**PLEASANT PRAIRIE PLAN COMMISSION MEETING
VILLAGE HALL AUDITORIUM
9915 39th AVENUE
PLEASANT PRAIRIE, WISCONSIN
6:00 P.M.
MARCH 9, 2015**

- A. Consider the request of Peter Kucha, of Eppstein Uhen Architects, Inc., agent for Uline for approval of **Preliminary Site and Operational Plans** for mass grading and preliminary approval of an office building and site improvements for a Uline Headquarters Office building (H2) generally located at the 11200 block of 120th Avenue (West Frontage Road).

Consider the request of Peter Kucha, of Eppstein Uhen Architects, Inc., agent for Uline for approval of **Preliminary Site and Operational Plans** for mass grading and preliminary approval of an office building and site improvements for a Uline Headquarters Office building (H2) generally located at the 11200 block of 120th Avenue (West Frontage Road).

ONSITE CIVIL ENGINEERING INFRASTRUCTURE PLANS

SHEET C-4 of C-14

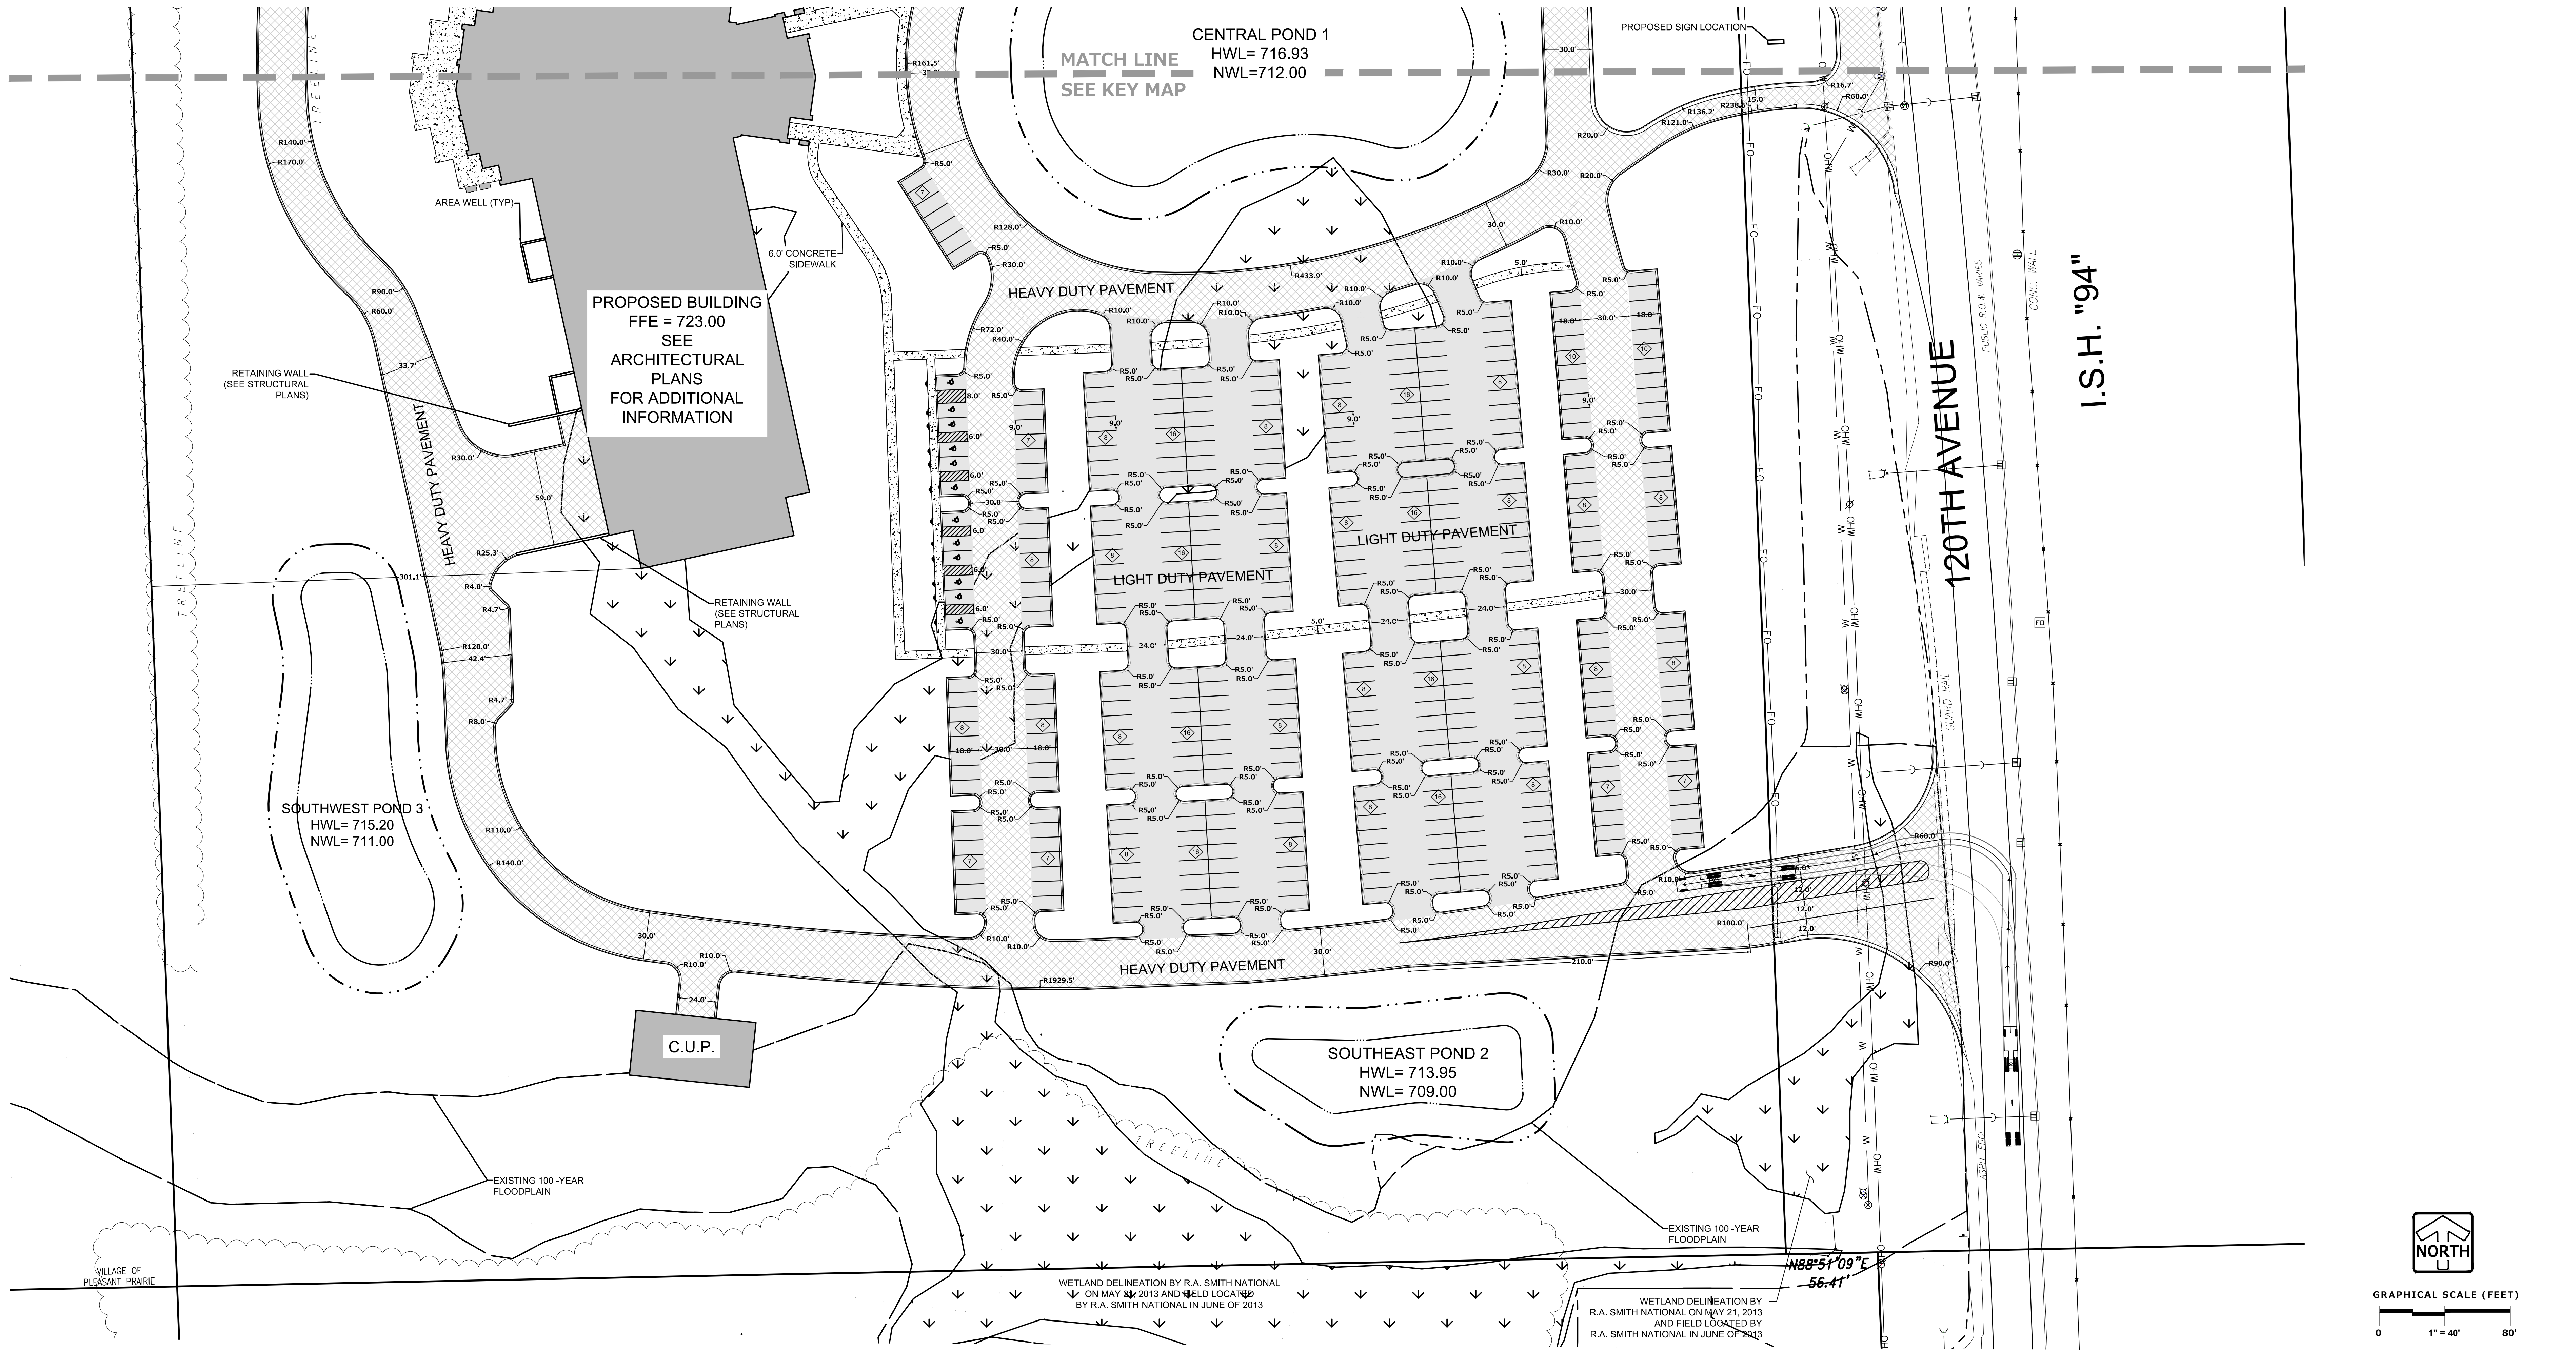
- c. Label/define C.U.P. in the plan sheet on Sheet C-4.
 - d. The 102th Avenue right-of-way shall be labeled and shown on the plans. The proposed monument sign appears to be located in the 120th Avenue Frontage Road right-of-way and must be set back 15 feet from the edge of the right-of-

- (1) Revise note 16 (Asphaltic Concrete Paving Specifications) to utilize the current edition of the State Highway Specifications.
 - (2) Show travel directions of any one way traffic locations on the site plans.

SHEET
C-5
OF
C-14

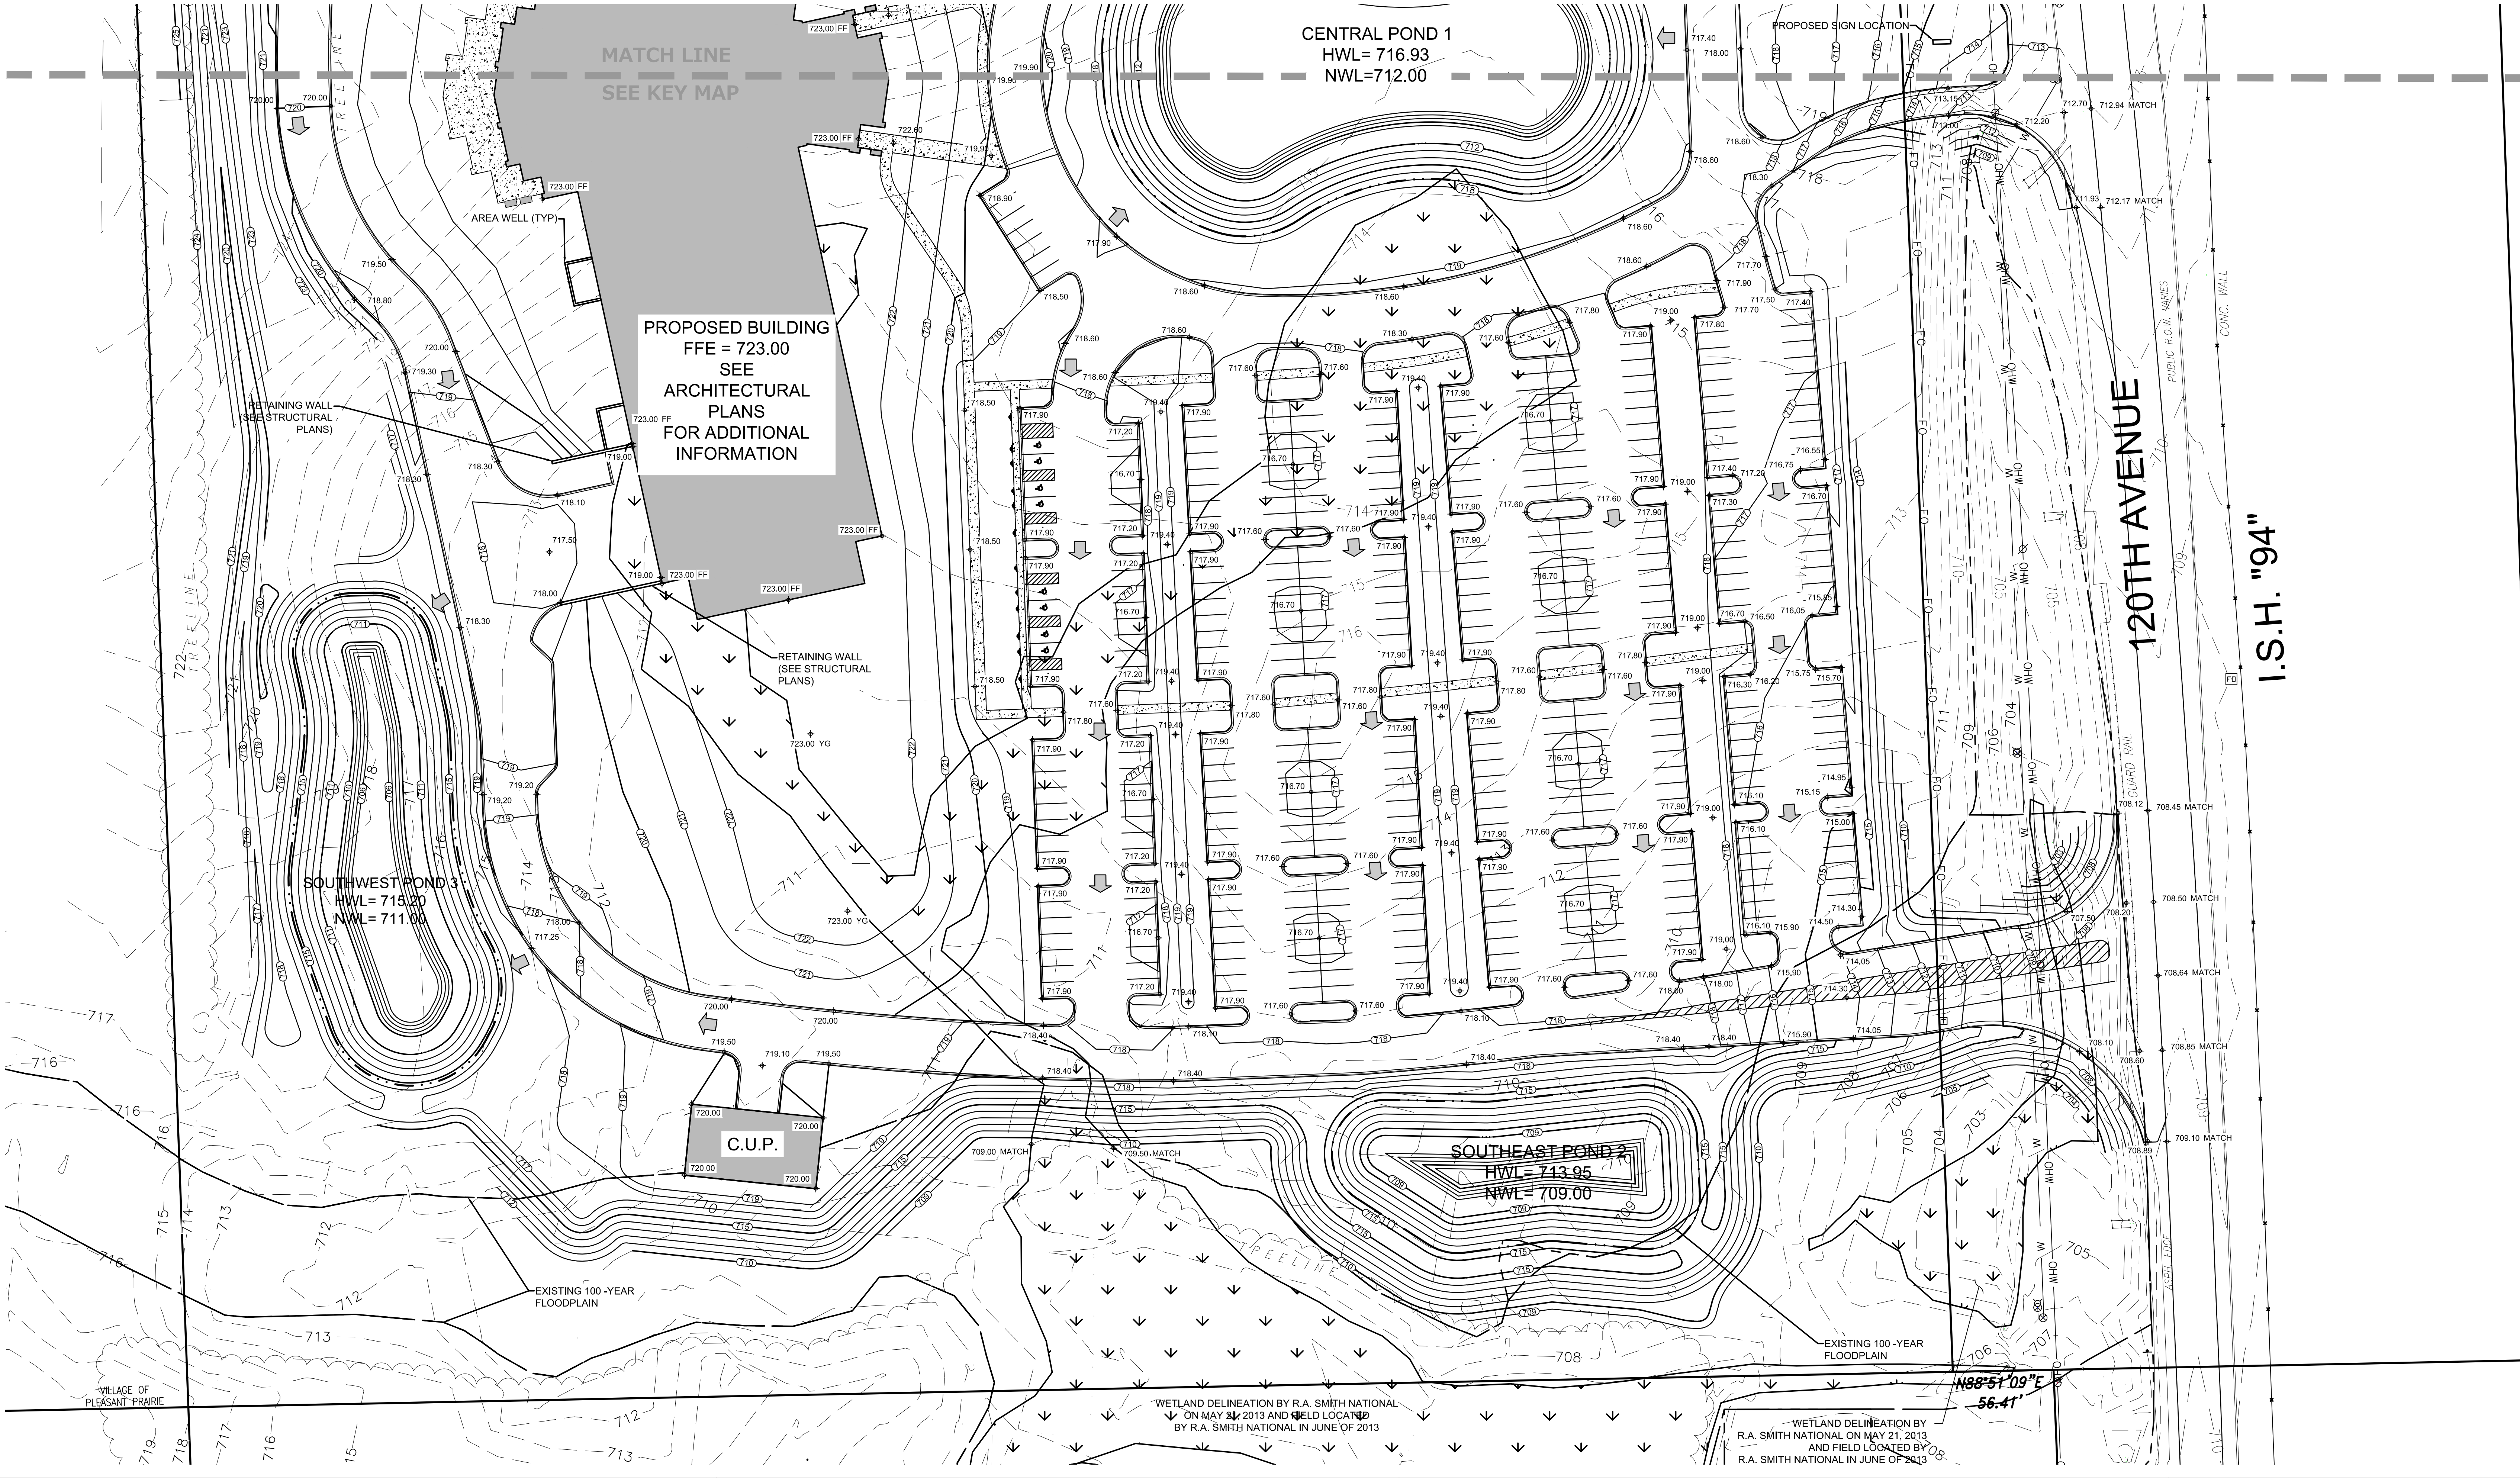
- (3) Additional plans and details will be required for 120th Avenue improvements.
 - iii. Grading Plan (Sheets C-5 & C-6):
 - (1) Revise Note 16 to state "Village of Pleasant Prairie" instead of "Kenosha County".

- (2) Add cross slopes to driveways. 2% typical, 1% minimum.
 - (3) Consider adding sidewalk between the north parking lots and the building.
 - (4) Show all storm sewer piping, inlets and manholes on the grading plan sheets.

- (5) Label the pond emergency overflow spillways on the plans.
 - (6) Grading south of the C.U.P. appears to encroach into waterway. This shall be evaluated by the design engineer.
